Amendment to Application No. 2117

Location N.S. 7th St 207' 6" of 1st Ave

Amendment to Application No. 2117 N. B. 1899

Location N. S. 7th St. 207' E of 1st Ave.

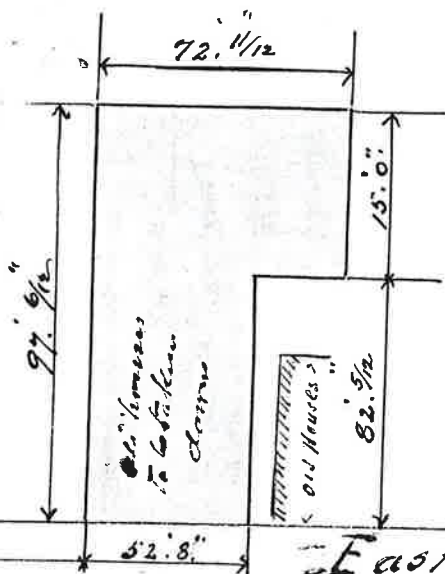
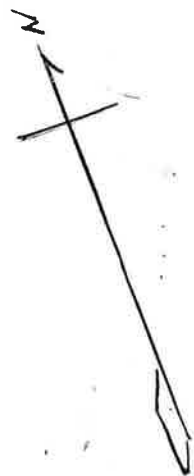
The general scheme for iron work to be used as follows and as per drawings filed herewith

1st Story columns and cellar columns running through two stories to be made of 2-8" channels $11\frac{1}{4}$ " and 2 plates $9 \times \frac{1}{4}$ "

Columns which run through cellar only to be $6 \frac{5}{8} \times 3\frac{1}{4}$ " cast iron.

Girders supporting side walls to be 2-10" I's 25 $\frac{1}{2}$ "

Bearing plates under roof trusses to be $12 \times 14 \times \frac{1}{2}$ " forming part of shoe on truss and resting on stone templets.

Construction of tower as per revised plan submitted herewith

Size of sidewalk beams 12" I's $31\frac{1}{2}$ " with skewbacks of 12" channels 20 $\frac{1}{2}$ "

Where sidewalk beam comes over doorway it is to be supported by 12" channel 20 $\frac{1}{2}$ ".

Truss details as shown on revised section filed herewith
